# RESPONSE TO AN BORD PLEANÁLA OPINION

**PROPOSED STRATEGIC HOUSING DEVELOPMENT ON LANDS AT THE  
FORMER GREENPARK RACECOURSE, DOCK ROAD, LIMERICK**

**VOYAGE PROPERTY LIMITED**

**October 2021**

Figure 2.1: Site Plan showing proposed Neighbourhood Areas (Source: Reddy Architecture + Urbanism)

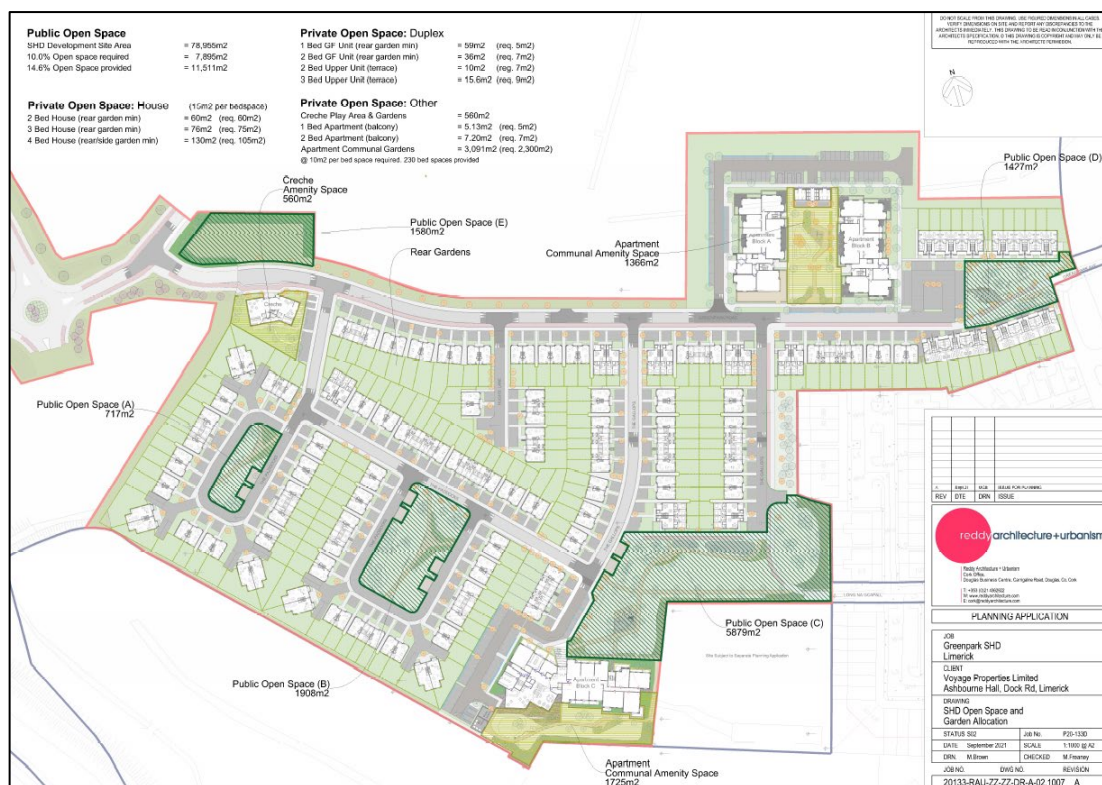
*"Further consideration/justification of the documents as they relate to the design and layout of residential development. The prospective applicant should satisfy themselves that the proposed design and layout provide the optimal urban design and architectural solution for this site and are of sufficient quality to ensure that the proposed development makes a positive contribution to the character of the area over the long term. In this regard, the submitted documents should allow for particular consideration of the following matters.*

The proposed SHD scheme has been broken down into series of Character Areas/ Neighbourhood Areas. This is shown on Reddy Architecture + Urbanism's Dwg. No. 20133-RAU-ZZ-ZZ-DR-A-02.1005 Rev A and pages 37-40 of the enclosed *Design Report* which sets out the design rationale for each character area. These include:

- Neighbourhood/ Character Area 1: Greenpark Road
- Neighbourhood/ Character Area 2: Greenpark Road Upper
- Neighbourhood/ Character Area 3: The Paddocks
- Neighbourhood/ Character Area 4: The Gallops

Figure 2.4: Extract from Reddy Architecture and Urbanism's *Design Report* (page 24) showing the pedestrian routes through the proposed SHD and connection into adjoining development.

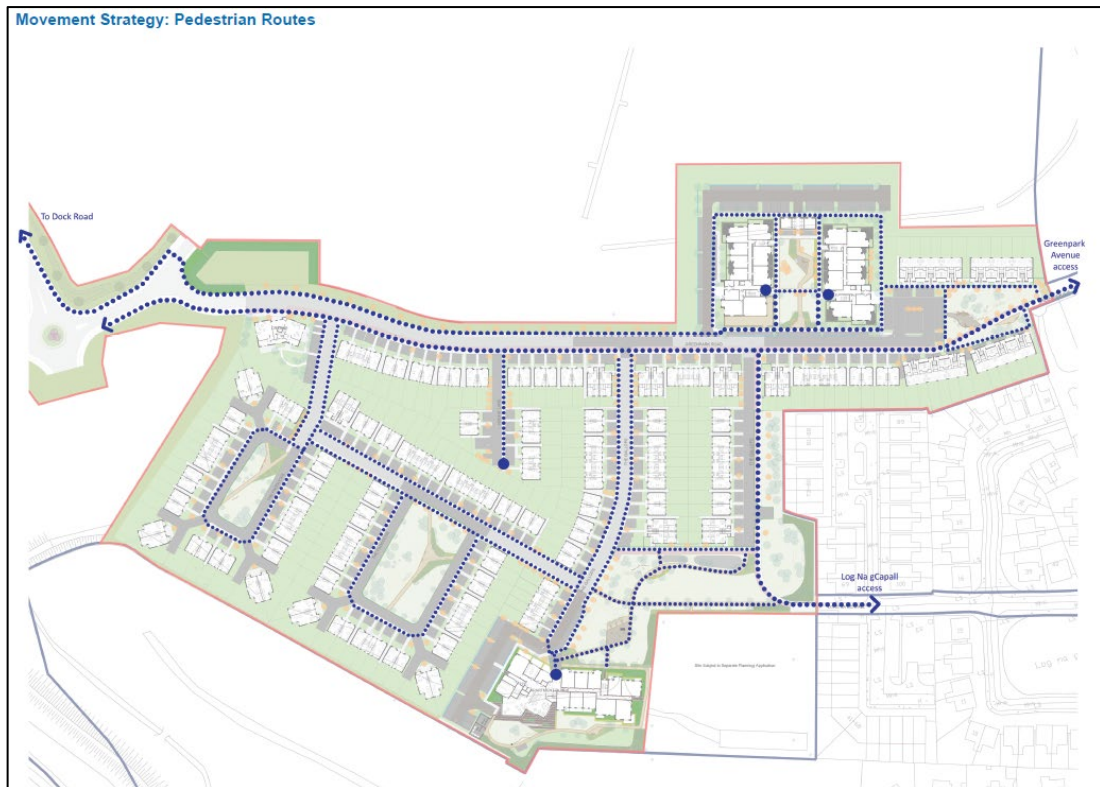
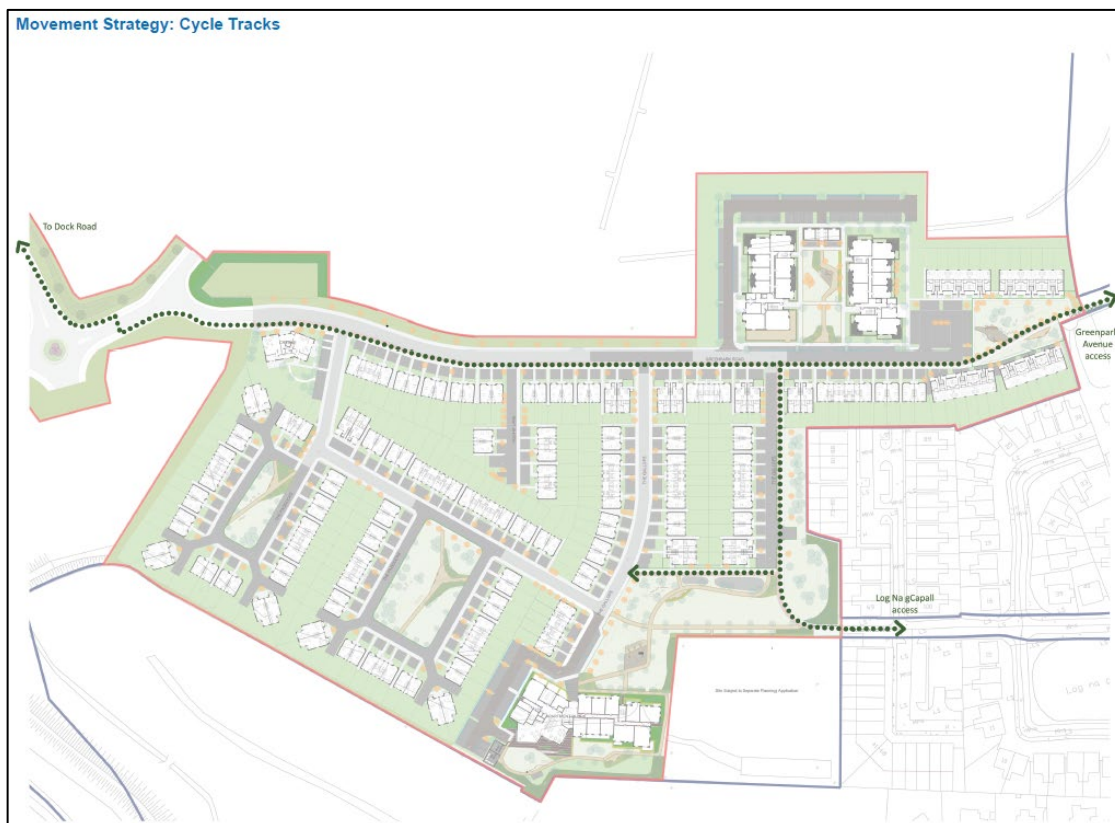
*“Further consideration of the documents as they relate to road / pedestrian / cycle connectivity to South Circular Road via adjacent residential areas to the north and east of the site, to include the capacity of existing roads, pedestrian and cycle infrastructure at these locations, as well as the potential cumulative impacts of the development of adjacent sites within the overall Racecourse lands in the context of the proposed Masterplan and any current proposals to develop adjacent sites within the Masterplan area, also the development permitted Reg. Ref. 17/1190 ABP-302015-18. The prospective applicant is also advised to consider connectivity to adjoining development sites within the Masterplan lands and to potential future connectivity to the lands owned by Limerick City and County Council to the south of the development site. The following matters should also be taken into consideration:*

The enclosed *Design Report*, prepared by Reddy Architecture + Urbanism, also addresses the proposed movement strategy and provides an overview of the cyclist and pedestrian routes through the site and the connectivity achieved with the surrounding area in diagrammatic form. The relevant extracts are included below.

**Figure 2.6:** Extract from Reddy Architecture + Urbanism’s *Design Report* (page 8) showing indicative vehicular connectivity across Masterplan lands and adjoining development.

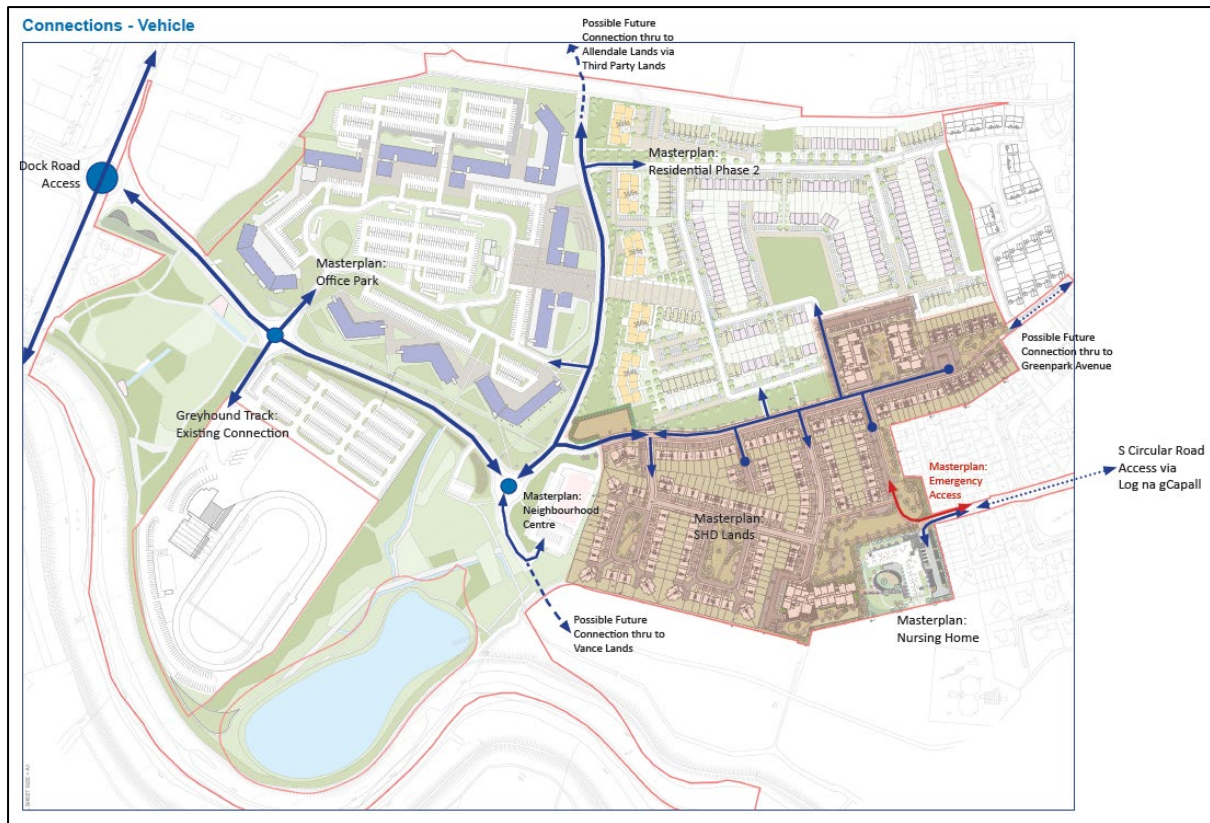
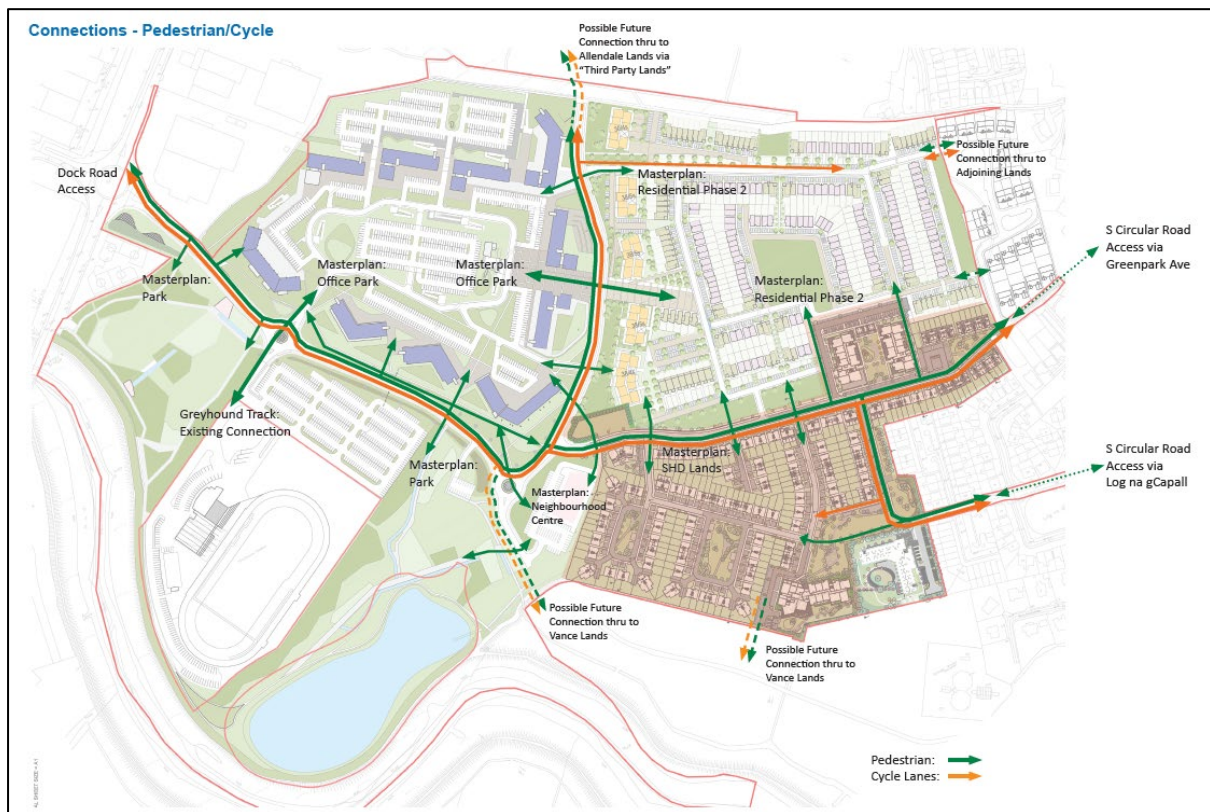
302015-18. The prospective applicant is also advised to consider connectivity to adjoining development sites within the Masterplan lands and to potential future connectivity to the lands owned by Limerick City and County Council to the south of the development site. The following matters should also be taken into consideration:

The *Design Report* also provides an overview of the proposed connectivity and linkages across the whole Masterplan area. As well as the proposed access road that connects into Dock Road, this includes potential future vehicular connectivity with Alandale lands to the north and the Council owned lands (‘Vance lands’) to the south.

In terms of cycle and pedestrian connectivity, the Masterplan provides for multiple routes across the masterplan and into surrounding adjoining development/ land to the north, south, east and west.

**Figure 3.1: Land Use Zone Map (contained within Limerick City Development Plan 2010-2016) in the context of the subject site (denoted by the red line) (Source: Reddy Architecture + Urbanism (2021).**

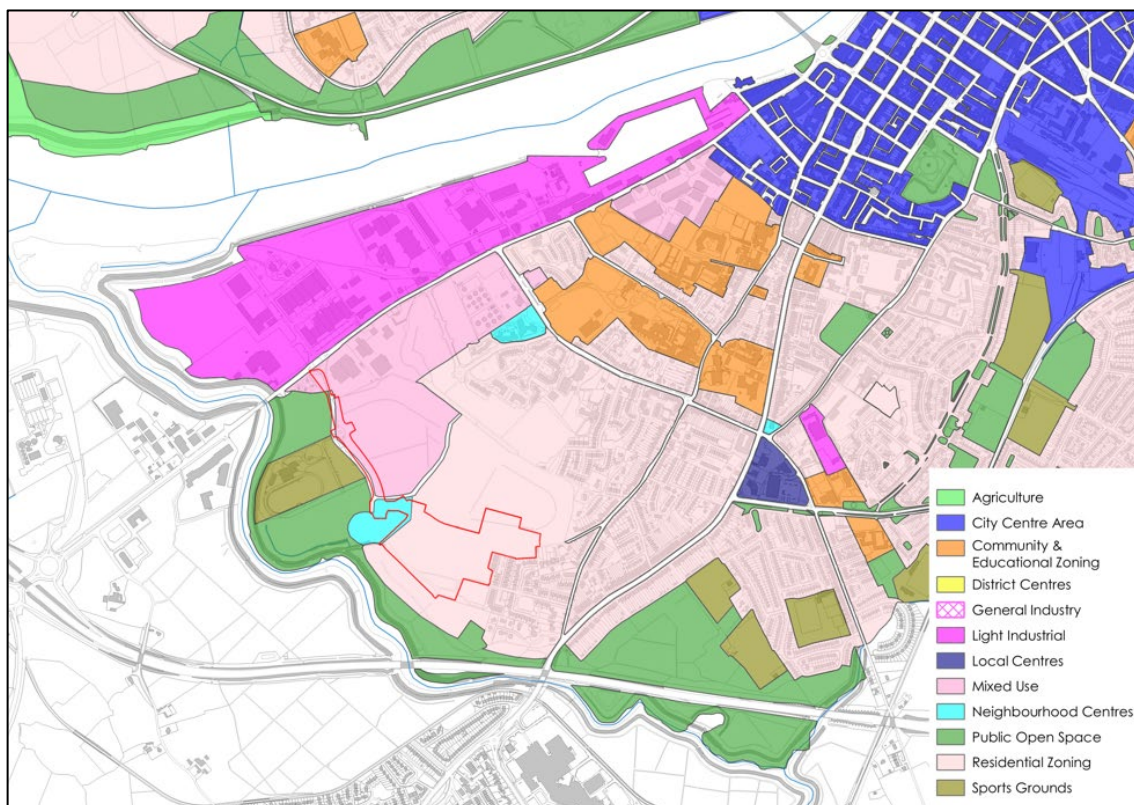
*“A site plan showing the layout of the proposed development in relation to the various zonings that apply to the site.”*

The enclosed *Statement of Consistency* prepared by Tom Phillips + Associates includes an indicative map which shows the SHD red line boundary in the context of the land use zonings that apply to the site. For ease of reference, this is also provided below:

Figure 3.2: Extract from Reddy Architecture + Urbanism's *Design Report* showing the updated site wide Masterplan

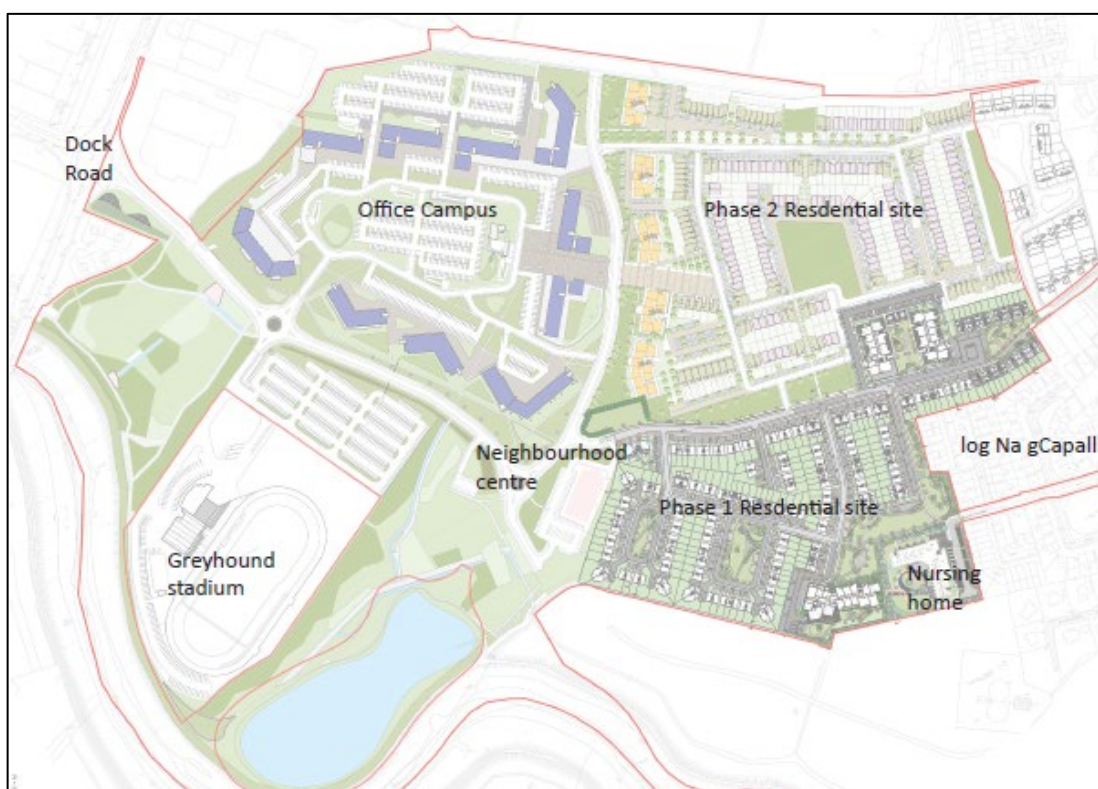
*“A Masterplan for the overall Racecourse lands in the ownership of the prospective applicant, which is to consider the strategic importance of the lands for the development of Limerick Metropolitan Area and is to address matters including land use zoning, residential density, housing mix, provision of a neighbourhood centre, childcare provision, details of the capacity of roads / pedestrian / cycle / public transport infrastructure and connectivity to adjoining areas, IW foul and watermain infrastructure, surface water drainage and flood risk, landscaping and biodiversity enhancement measures.”*

In responding to the Board's Opinion, particularly Issue No. 1 in respect of residential density and housing mix, the SHD scheme was amended to include, *inter alia*, two further apartment blocks. The site wide Masterplan has been updated to reflect this important amendment to Phase 1 (this SHD scheme). The updated Masterplan is contained within the *Design Report* (page 5 onwards) prepared by Reddy Architecture + Urbanism.

Figure 3.3: Extract from Reddy Architecture + Urbanism’s *Design Report* showing the indicative Masterplan Phasing.

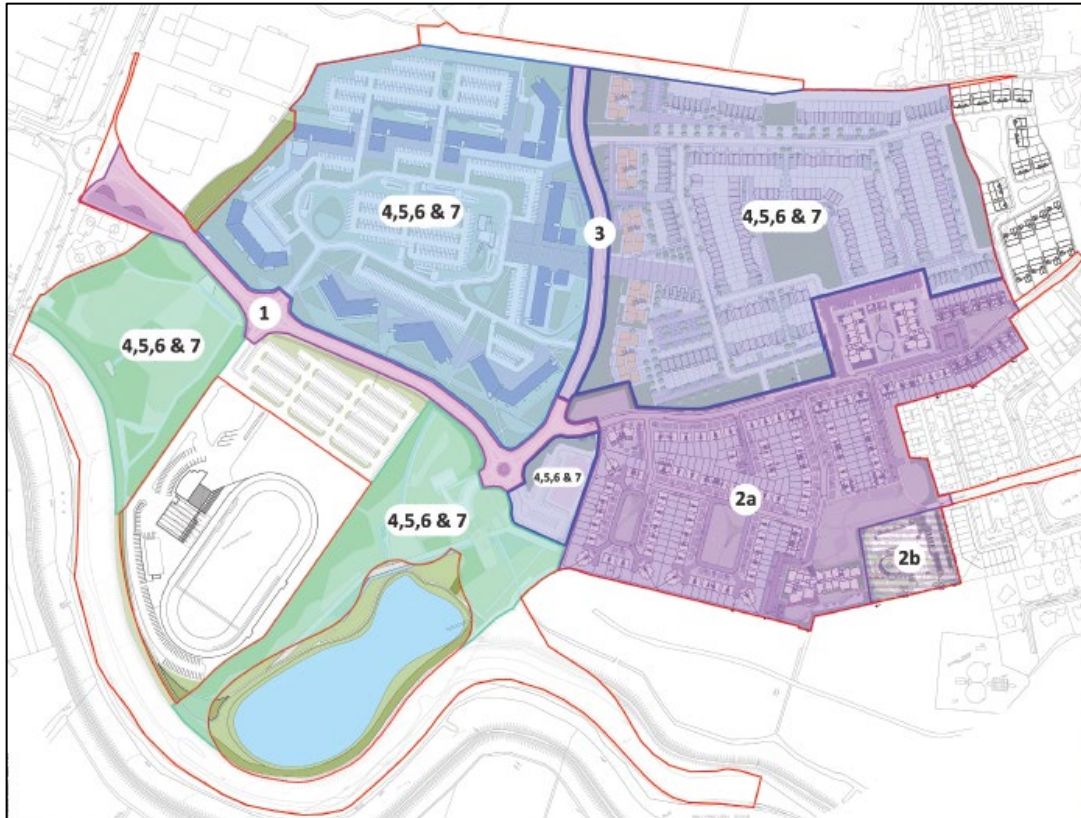
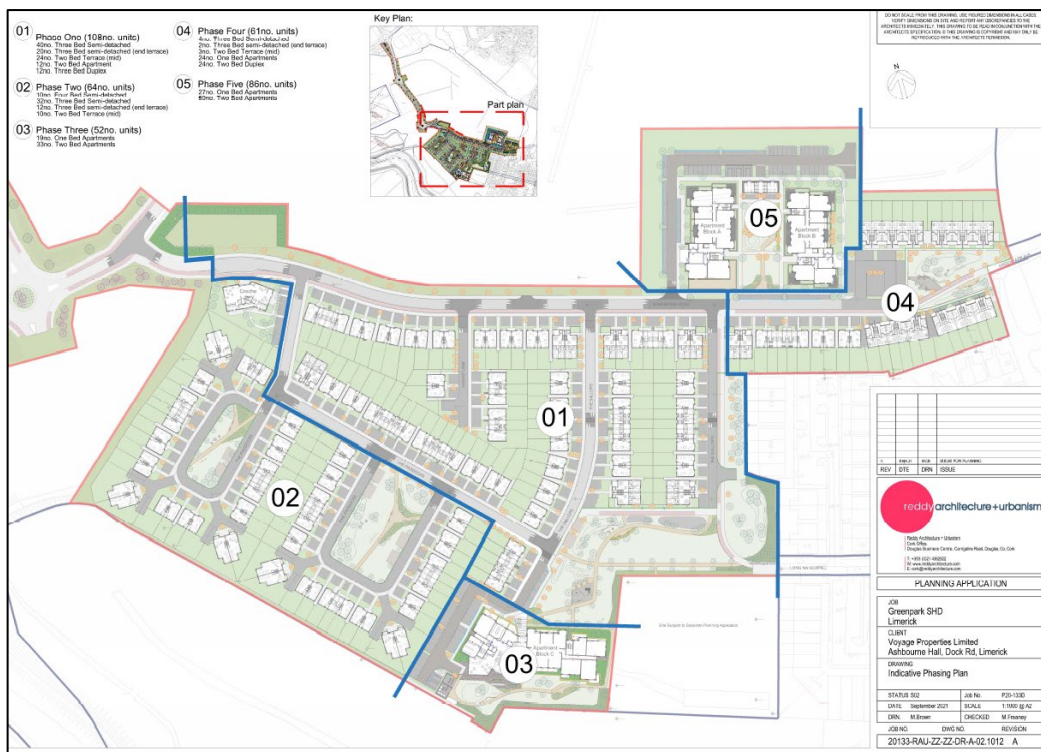
“A detailed phasing plan for the proposed development, in the context of the Masterplan for the overall Racecourse lands.”

The enclosed *Design Report*, prepared by Tom Phillips + Associates, includes an indicative Masterplan phasing plan and supporting narrative.

This planning application is also supported by an *Indicative Phasing Plan* for the proposed SHD scheme. Refer to Dwg. No. 20133-RAU-ZZ-ZZ-DR-A-02.1012 Rev A for details. An extract is provided below.
